Parliament Precinct Future Accommodation Strategy (FAS)

Integrated Transport Assessment

| Appendix F – Resource Consent ITA RFI Response |

| То | Peter Coop | From | Sheyah Ballinger | | | | |
|---------|--|-----------|------------------|--|--|--|--|
| Subject | Resource Consent ITA RFI Response | | | | | | |

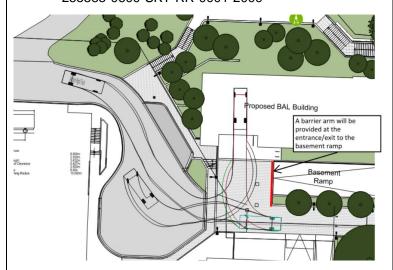
be a "vehicle barrier arm" near the western end of the basement ramp. Similarly, the architectural plan "Illustrative View H – Ballantrae Place" (P A6-13) appears to indicate a barrier near the top of the vehicle ramp to the basement. Can this please be clarified.

A barrier arm will be provided along the entrance/exit to the basement ramp. Trucks (both medium-rigid and large-rigid) are

able to enter and egress into the Bal Place loading area without infringing upon the barrier arm.

VEHICLE TRACKING MUSEUM STREET

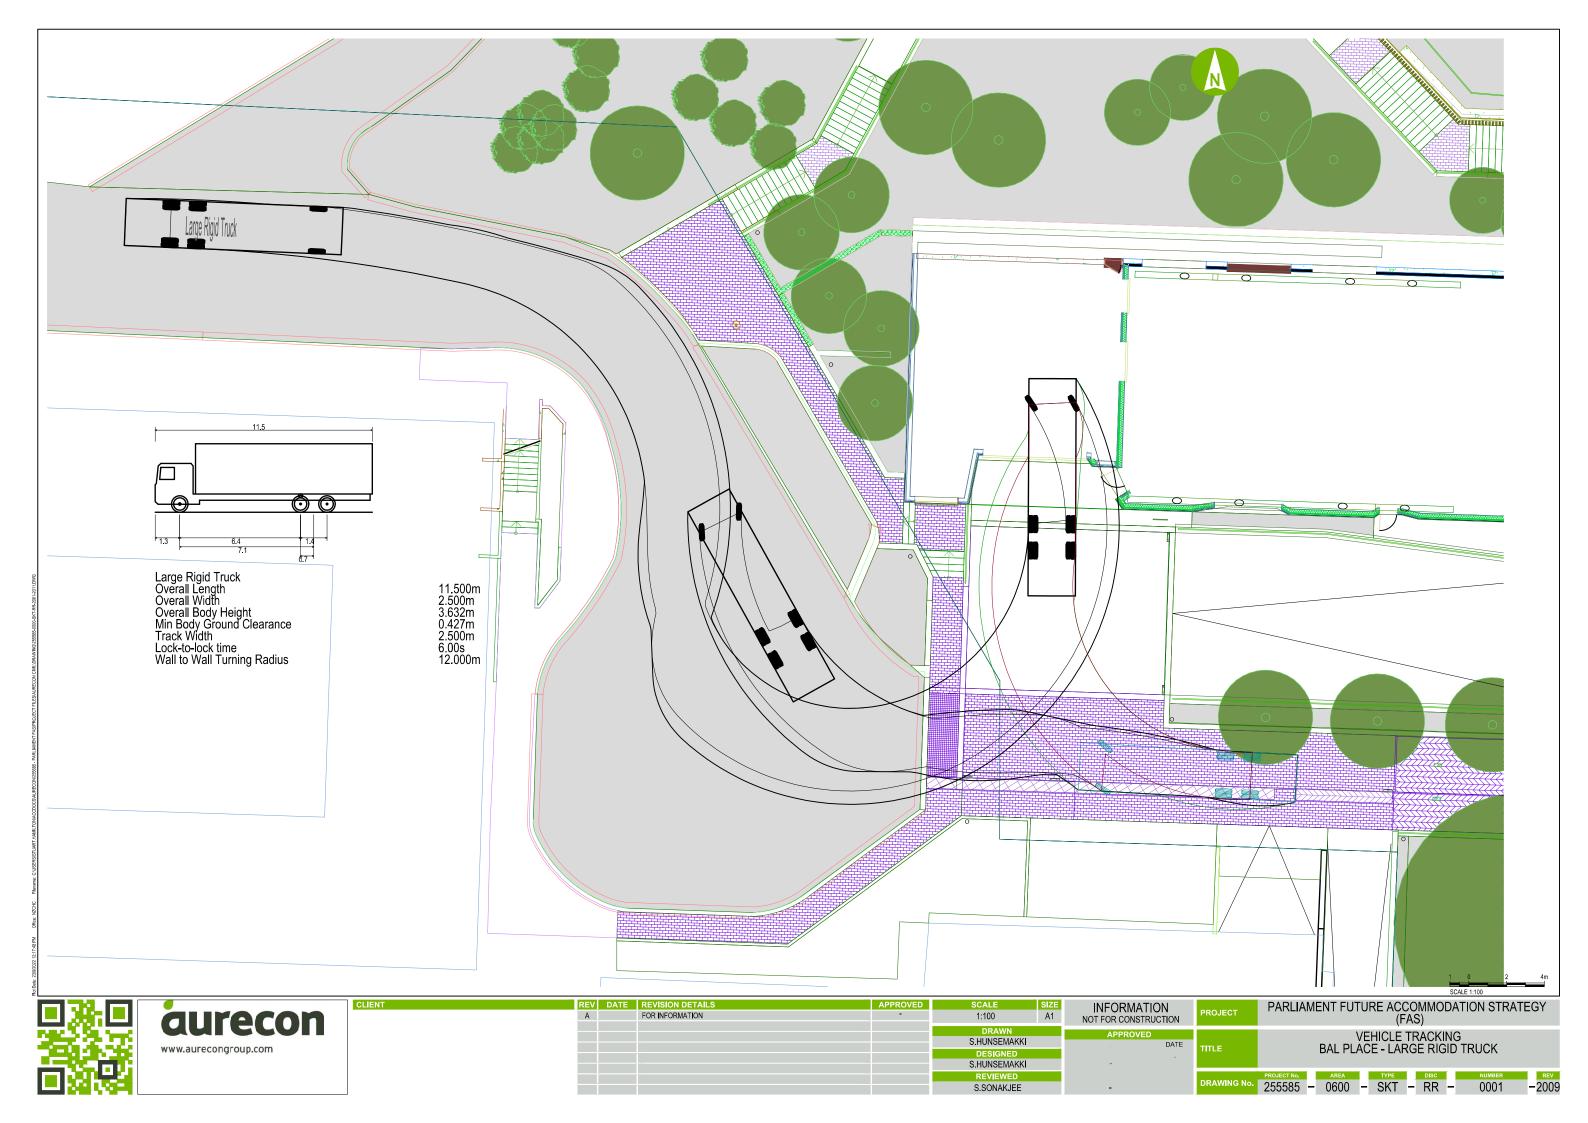
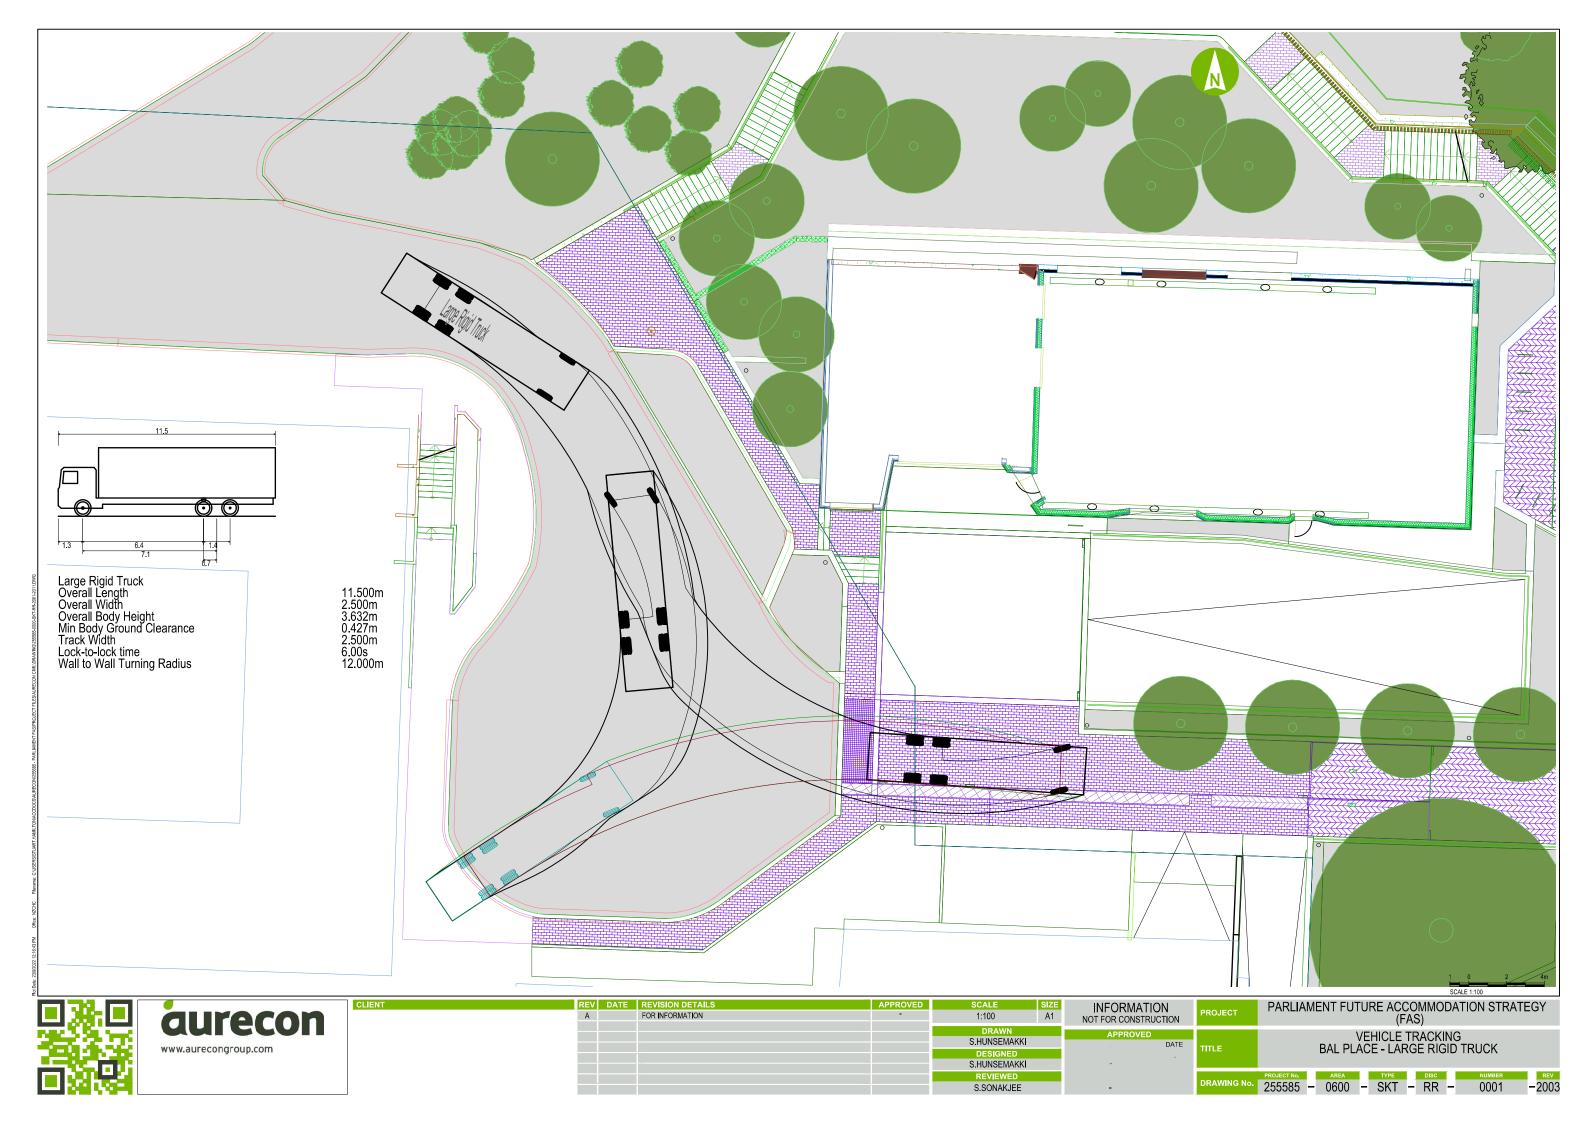
1. The Integrated Transport
Assessment has provided tracking curves for the turning area for a large (99 percentile) vehicle at the north end of Museum Street. It is recommended that the location of this turning area is highlighted and clarified on the relevant architectural plans, e.g. the "Detail Plan – Southern Museum Street" (P A2-10) or "Detail Plan – Northern Museum Street" (P A2-11).

Refer to the updated attached drawing for the Museum Street vehicle tracking:

- 255585-0600-SKT-RR-0001-2006 (VEHICLE TRACKING MUSEUM STREET - B99 PERCENTILE VEHICLE)
- 255585-0600-SKT-RR-0001-2005 (VEHICLE TRACKING MUSEUM STREET – LARGE RIGID TRUCK)
- 2. The Integrated Transport
 Assessment indicates that the
 service vehicles will turn around
 using the end of Ballantrae Place
 as a turning area and has
 provided tracking curves for a
 large truck and a medium truck
 entering the servicing area in the
 BAL building. However, these
 show that the vehicle would need
 to track over the central island at
 the end of Ballantrae Place.
 Please clarify if any changes are
 needed to the layout of Ballantrae
 Place.
